HISTORIC AND DESIGN REVIEW COMMISSION

HDRC CASE NO: 2021-605
ADDRESS: 828 NEVADA
LEGAL DESCRIPTION: NCB 3100 BLK LOT 8
ZONING: RM-4
CITY COUNCIL DIST.: 2
APPLICANT: Anthony Chen
OWNER: JCCH PROPERTY SOLUTIONS LLC
TYPE OF WORK: Window replacement
APPLICATION RECEIVED: December 08, 2021
60-DAY REVIEW: Not applicable due to City Council Emergency Orders
CASE MANAGER: Hannah Leighner

The applicant is requesting a Certificate of Appropriateness for approval to:

PROPOSAL FLOOR PLAN

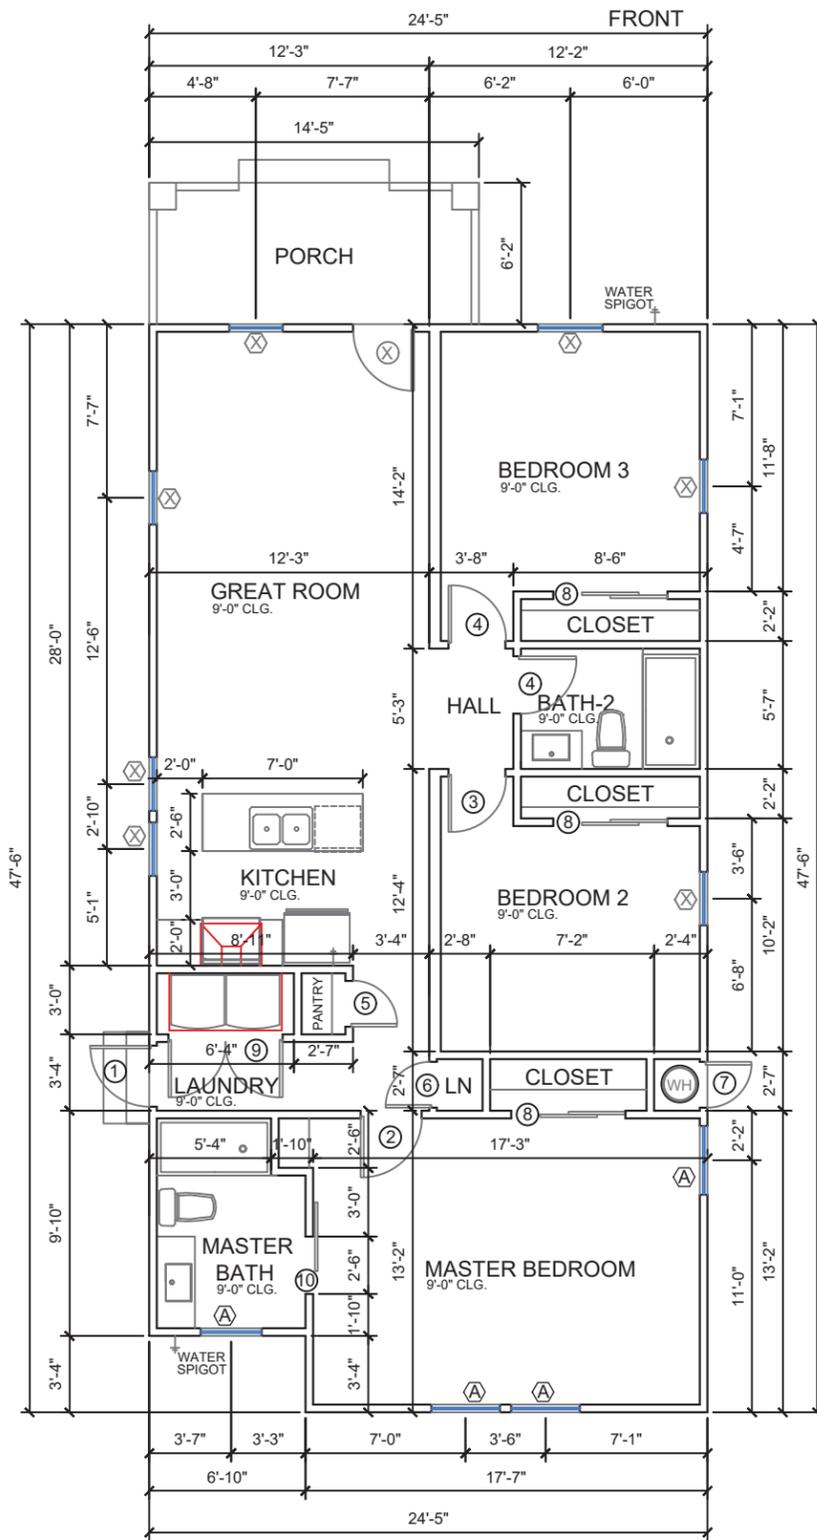
- f. **NEW WINDOW INSTALLATION:** The applicant is proposing to install three new windows on elevation of the rear addition. The addition encloses two existing wood windows. The Historic Design Guidelines for Additions 3.C.i recommend to salvage and reuse historic materials, where possible covered or removed as a result of an addition. Staff finds relocation of the two original windows to the addition exterior to be consistent with the guidelines.

2. Staff recommends approval of item 2 based on finding c with the stipulation that the applicant re-use the two previously-existing wood windows on the north elevation that are to be enclosed by the addition as recommended by the guidelines. Staff

recommends approval of the additional third window under the stipulation that the proposed new window is consistent with the guidelines and is submitted for review by staff prior to installation.

1 = Restored Historic
 2 = Jeld-Wen

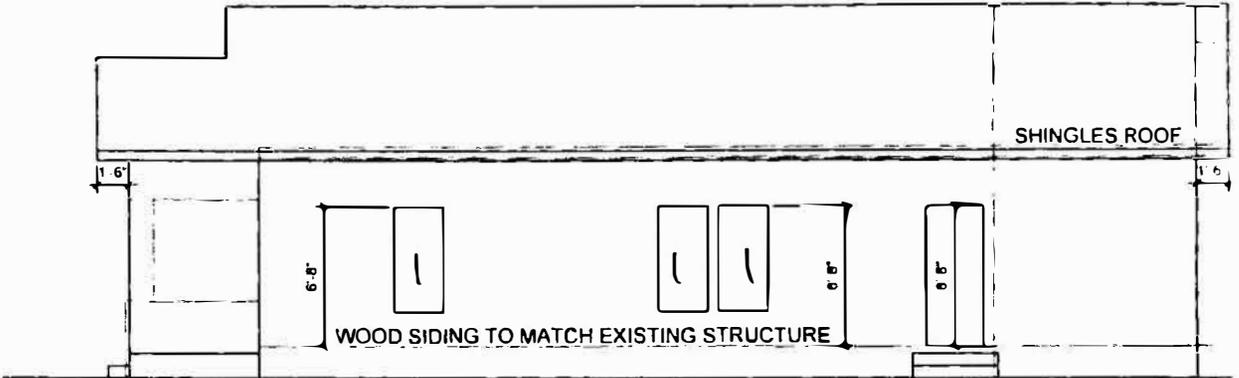
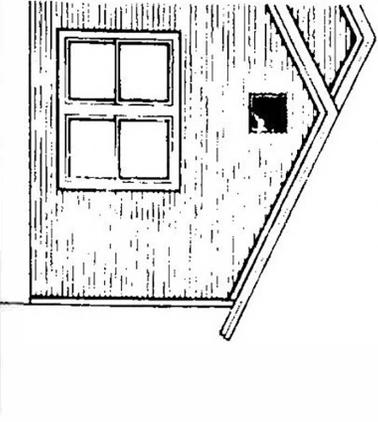
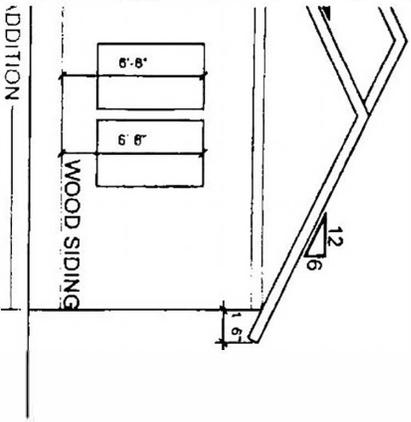
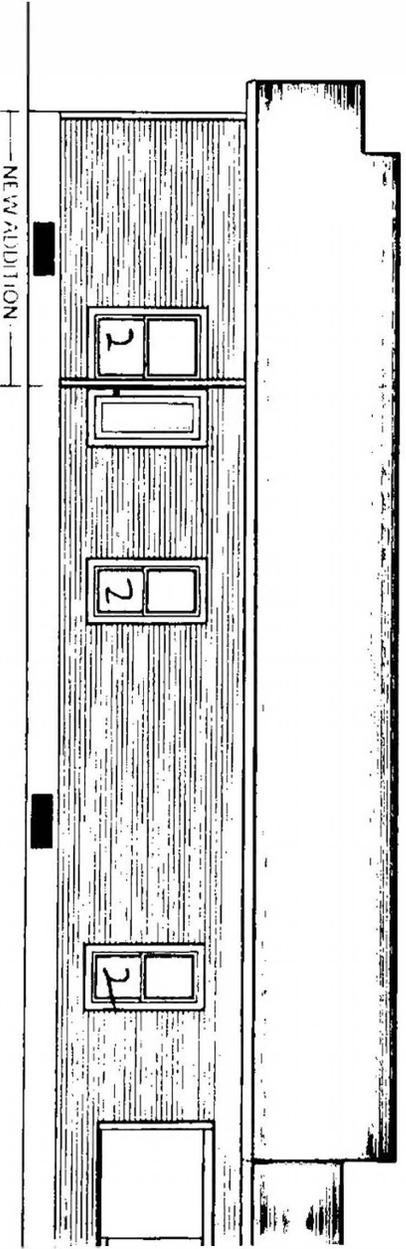
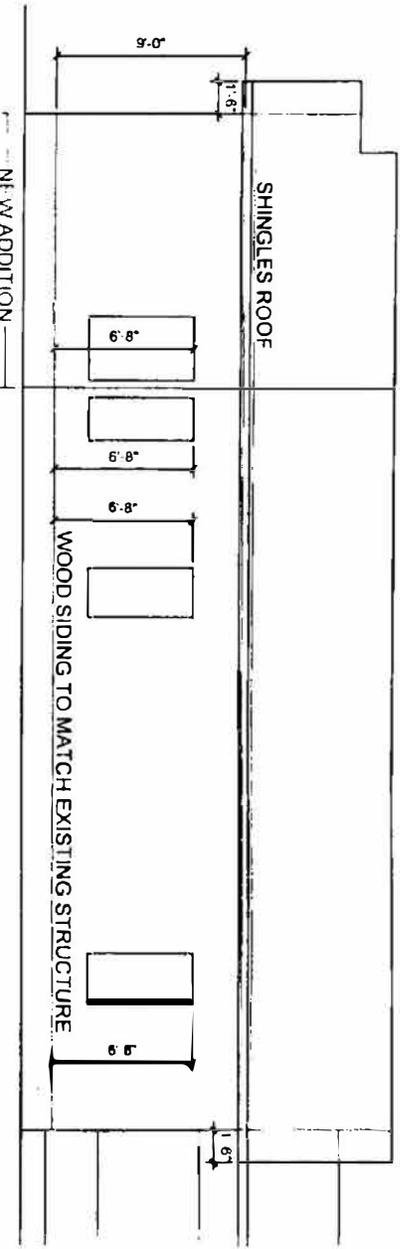
Per the commissioners recommendations, I proposing that we restore the historical windows with what usable material we have available to use as follows

1. Historical windows on the 2 fenestrations on the front elevation (North side of the home)
2. Historical windows on the 3 fenestrations on the right elevation (west side of the home)

I am proposing that Jeld-Wen windows be placed on all of the fenestrations for the new addition (south side of the home, and east side of the addition- facing away from the street), and on the 2 fenestrations on the east side of the home facing away from the street.
